PINES CAMPGROUND Upper View - South Half  
 Lower View - North Half

MICHIGAN DEPARTMENT OF CONSERVATION  
 PARKS AND RECREATION DIVISION

LUDINGTON STATE PARK  
 ELECTRICAL DISTRIBUTION SYSTEM  
 Scale 1"=30'

SHEET NO. 1	PLAN NO. E-115
OF 1

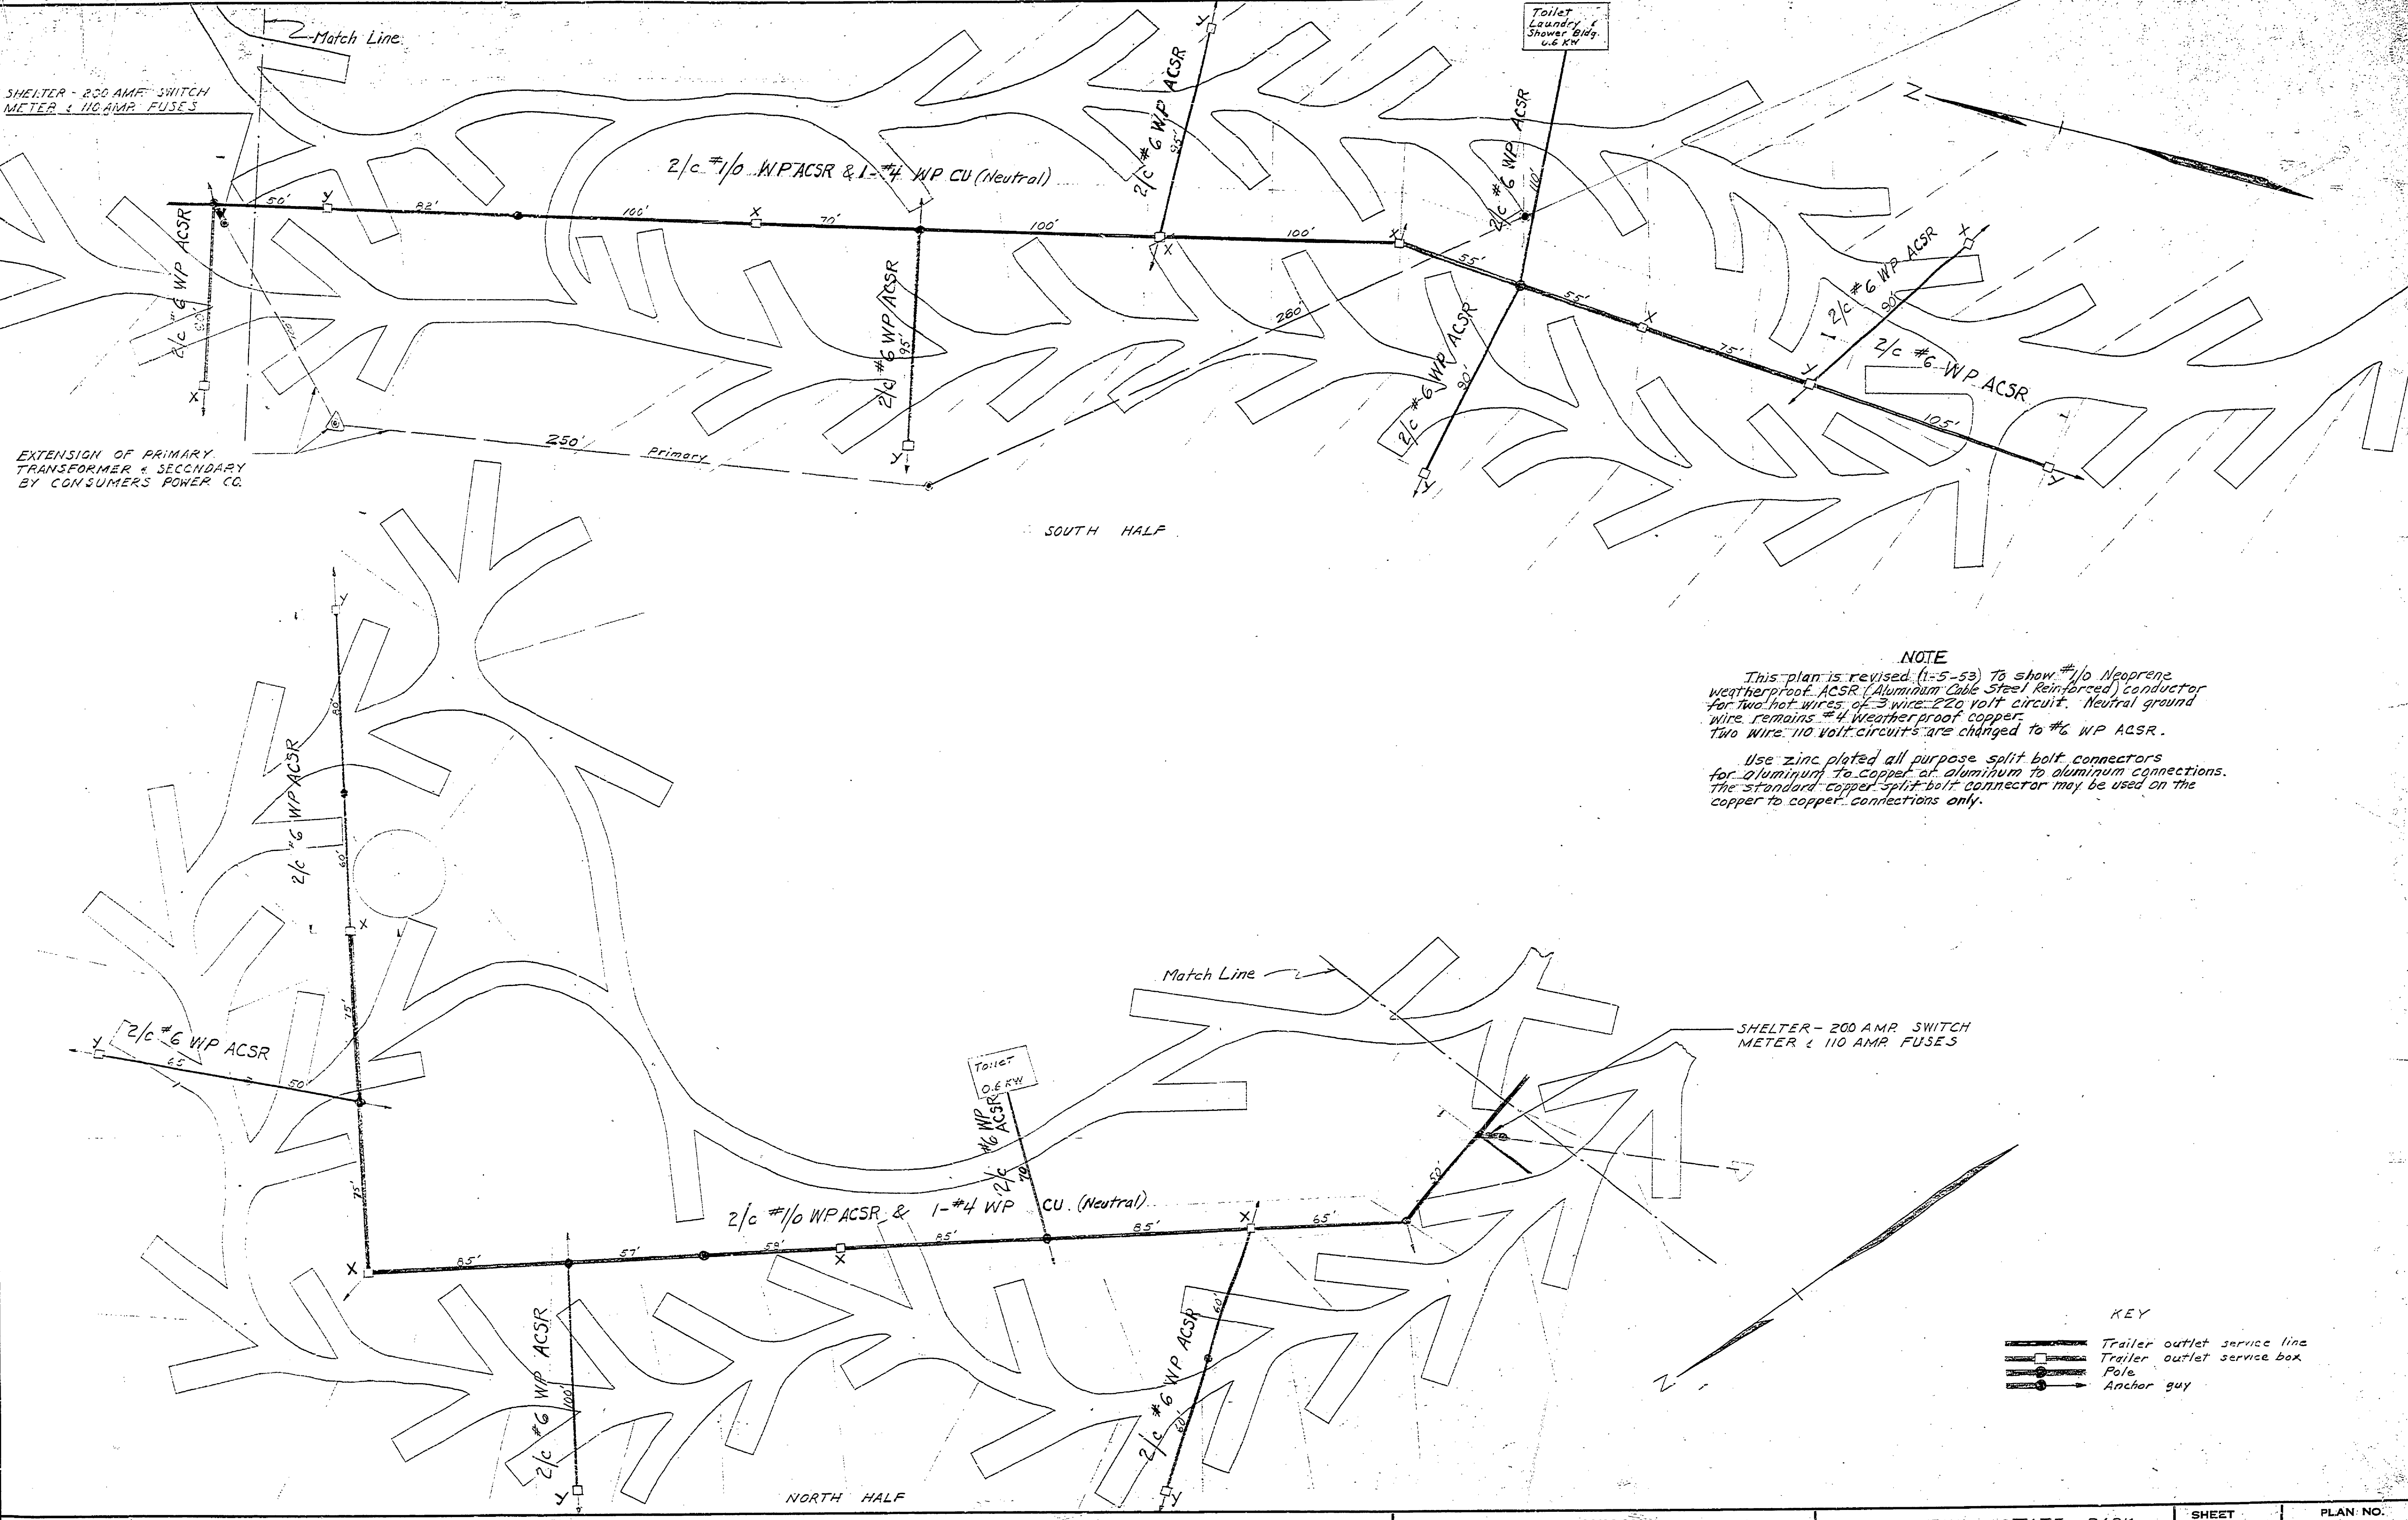
**NOTE**  
 This plan is revised (1-5-53) to show #10 Neoprene weatherproof ACSR (Aluminum Cable Steel Reinforced) conductor for two hot wires of 3 wire 220 volt circuit. Neutral ground wire remains #4 weather proof copper. Two wire 110 volt circuits are changed to #6 WP ACSR.  
 Use zinc plated all purpose split bolt connectors for aluminum to copper or aluminum to aluminum connections. The standard copper split bolt connector may be used on the copper to copper connections only.
